Addendum #	2	Date Issued	10-25-2024
Project Name Job #	DSU Woods Hall Improvements - Phase 2		20233600
Bid Date Time	November 20, 2024		2 pm MDT

THIS ADDENDUM AMENDS AND BECOMES PART OF THE CONTRACT DOCUMENTS FOR EAPC PROJECT 20233600 DATED 1-16-2024. EACH BIDDER SHALL ACKNOWLEDGE RECEIPT OF THIS ADDENDUM BY MARKING THE ADDENDUM NUMBER AND DATE ON THE BID FORM.

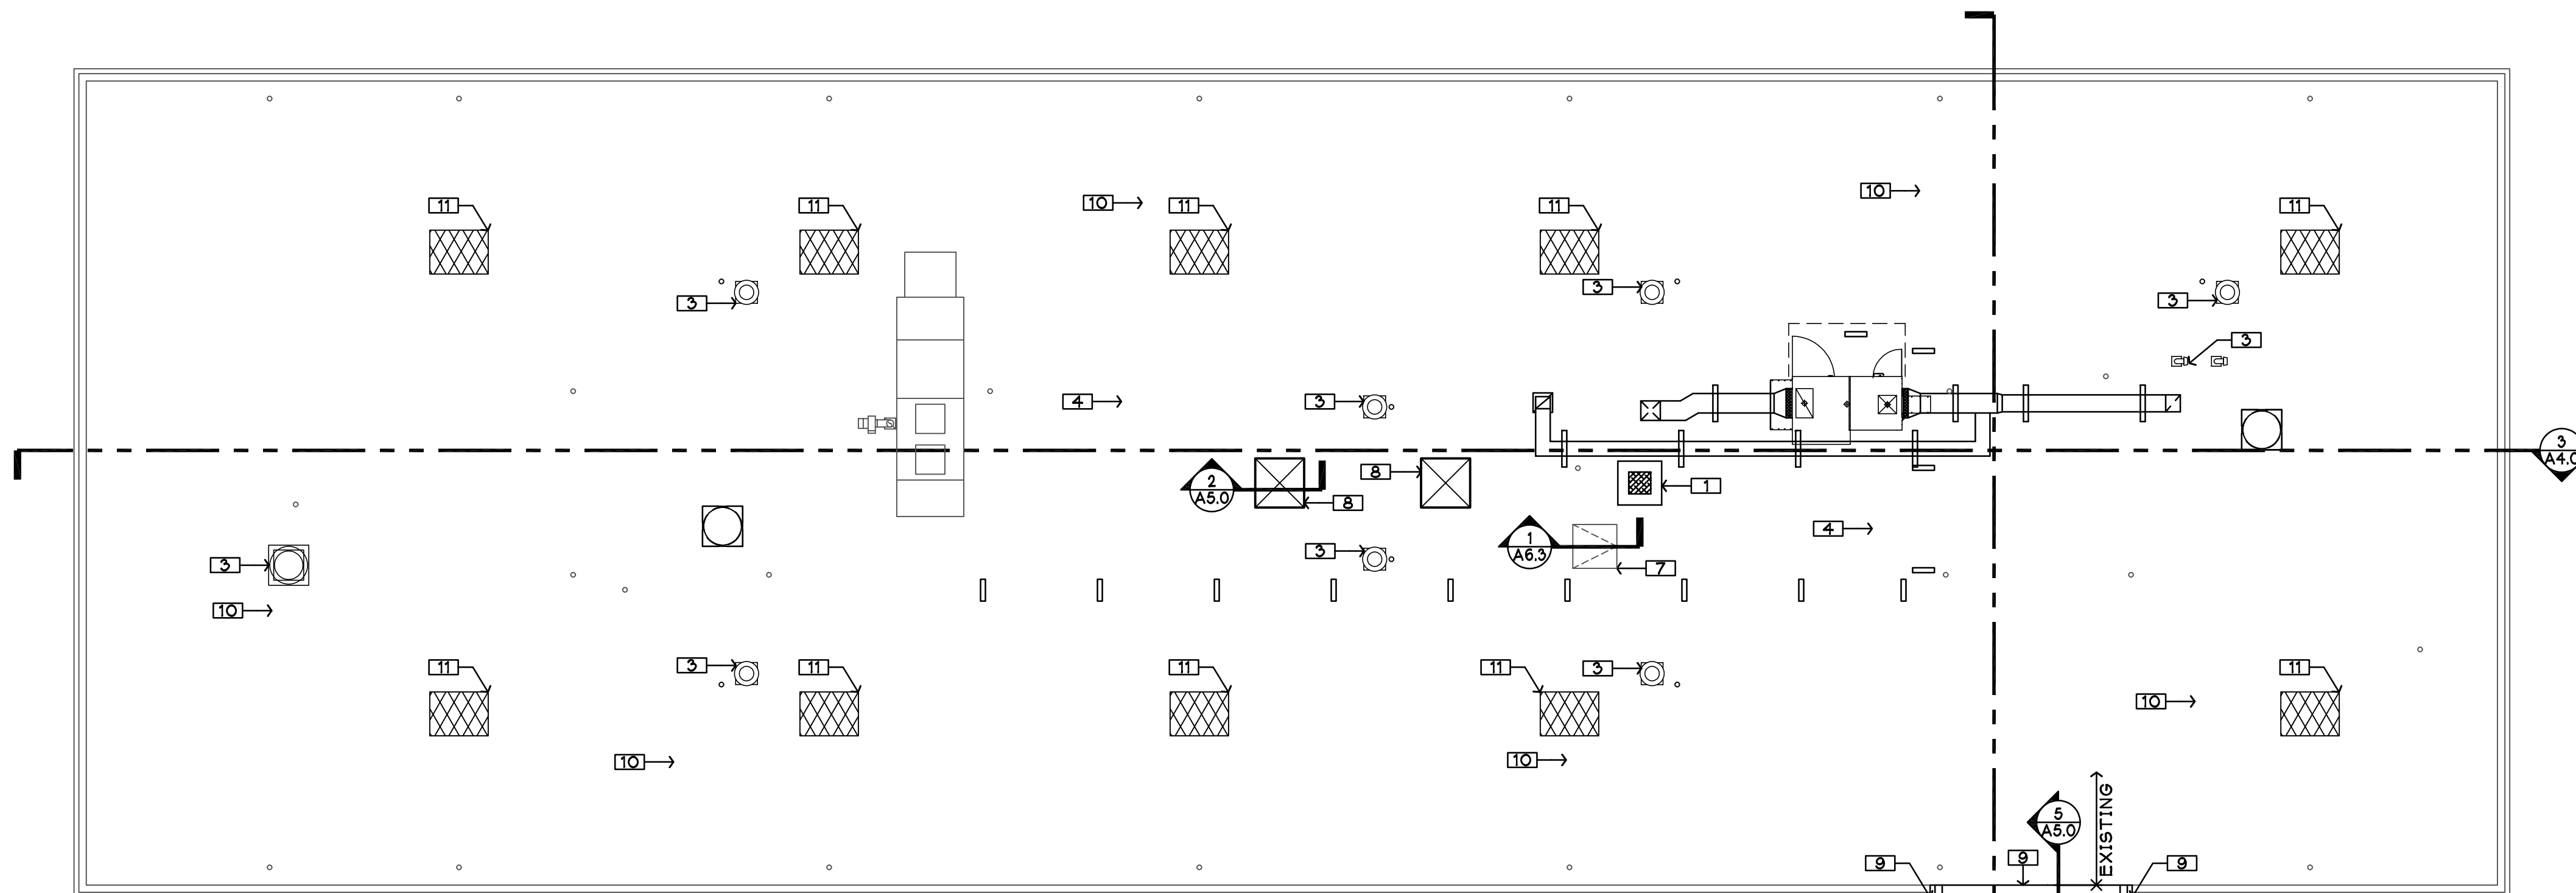
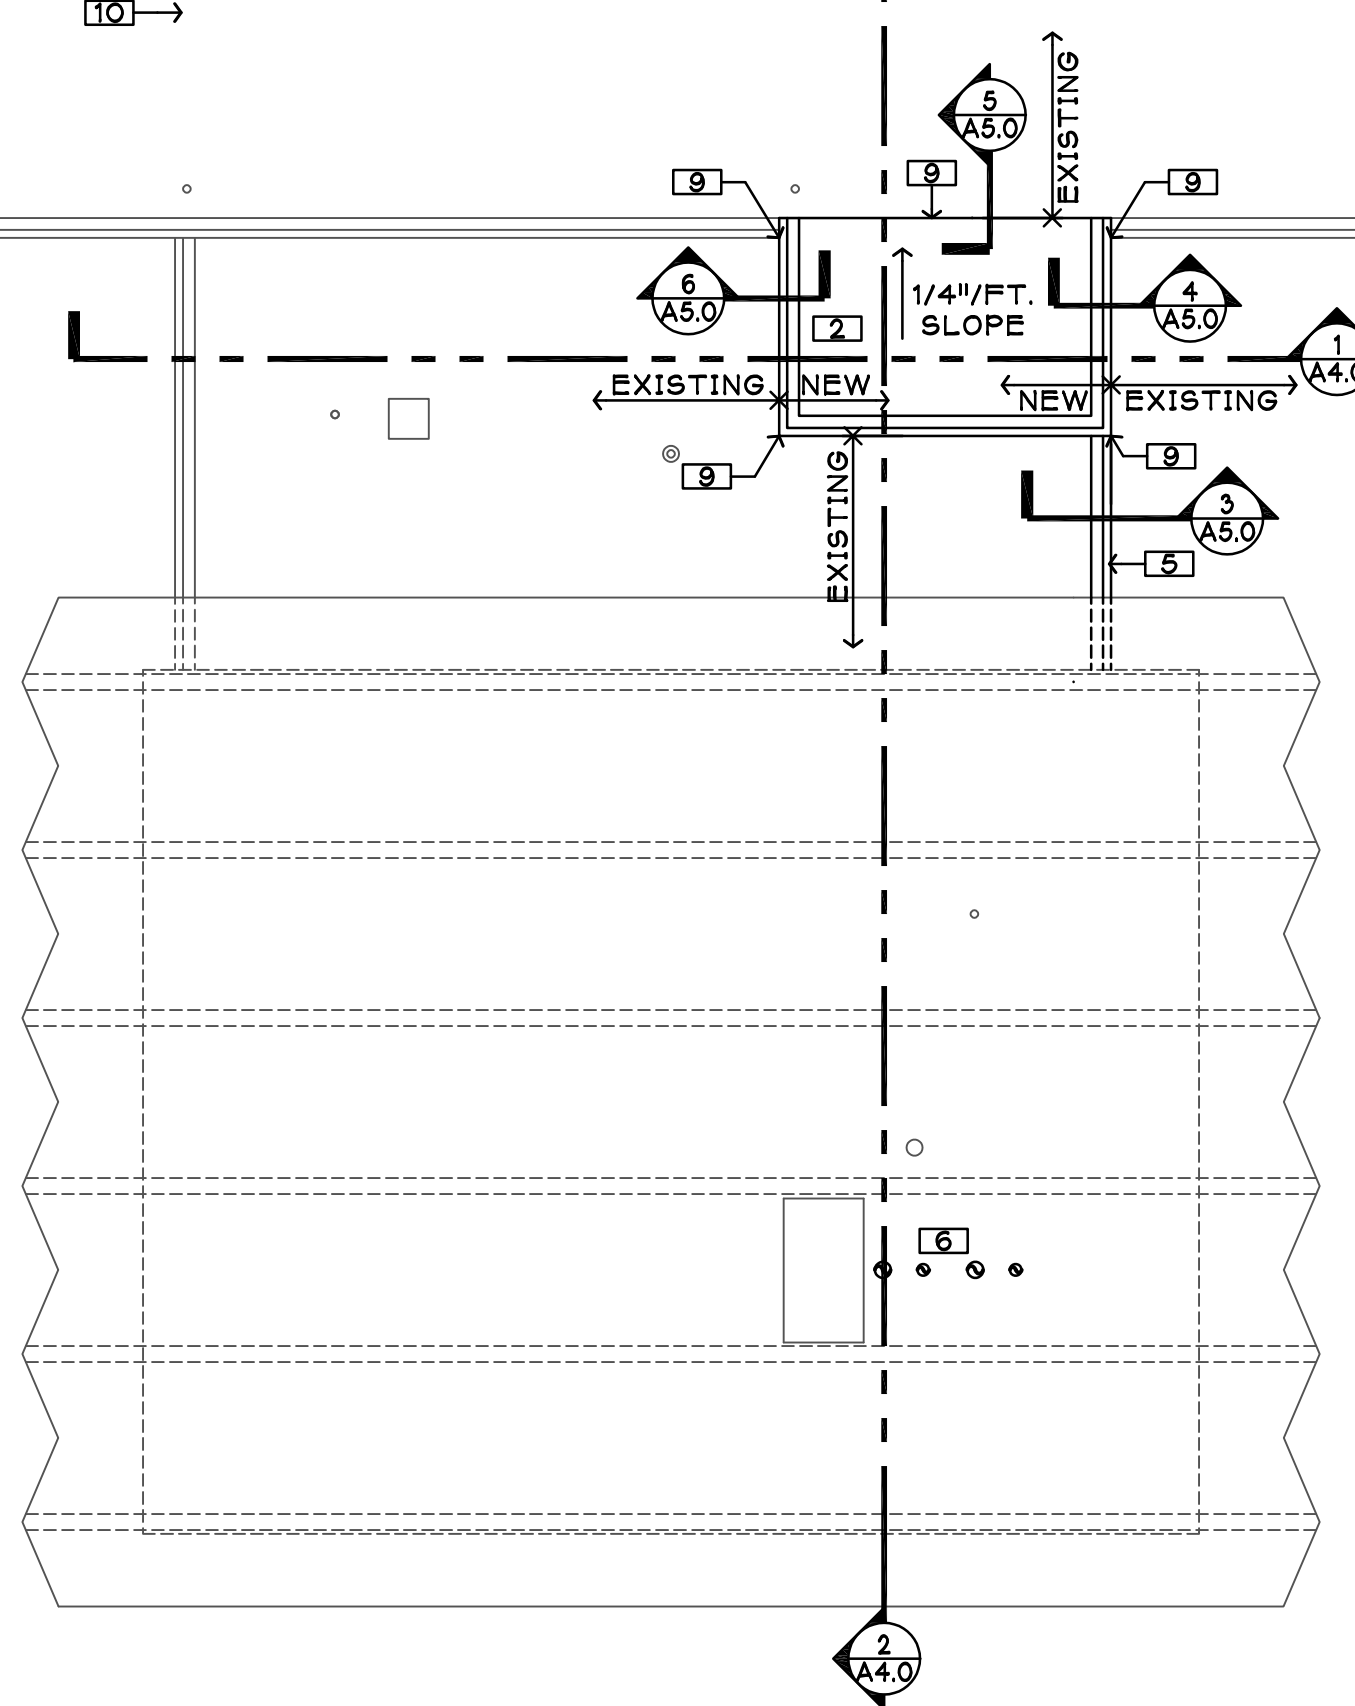
Replace sheet with revised sheet A5.0R, attached. Revision as needed for 3rd floor AC Alternate Bid G-4.

M0.1B

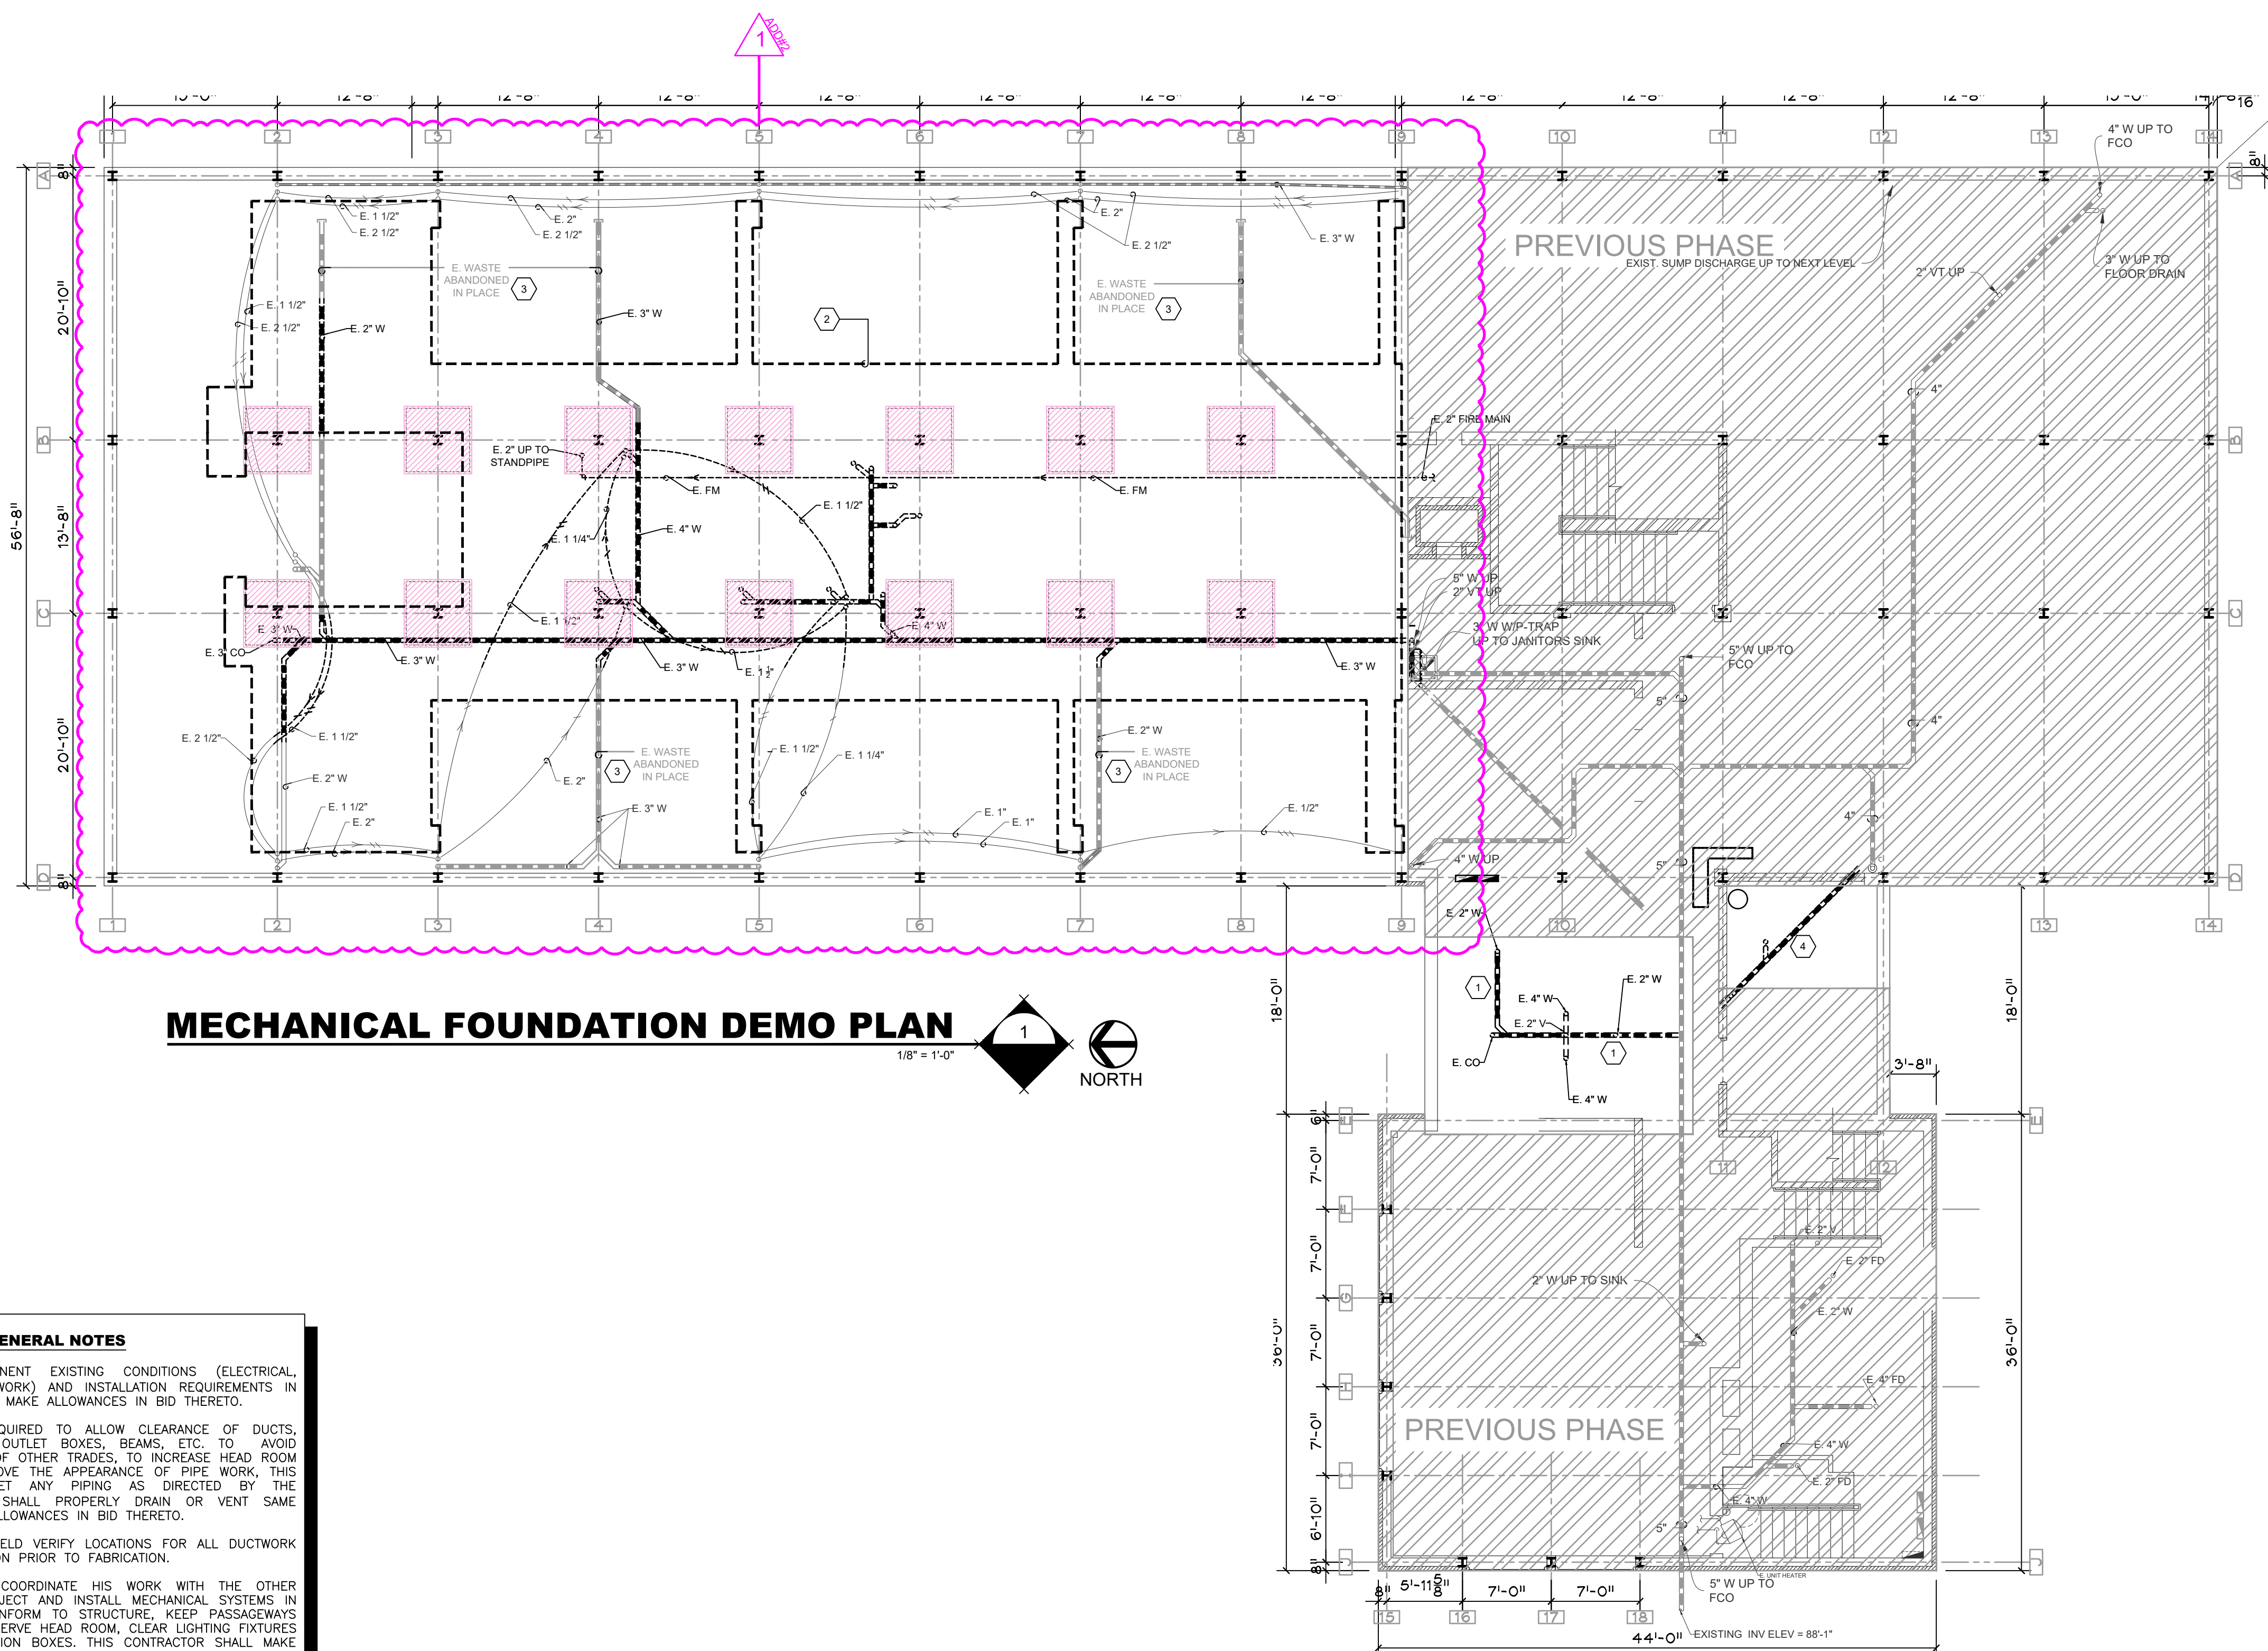
- a. Updated the drawing to extend the area of concrete demolition that the M.C. will need to coordinate with the G.C. for removal to add additional new waste piping.
- b. Updated and added keynotes.
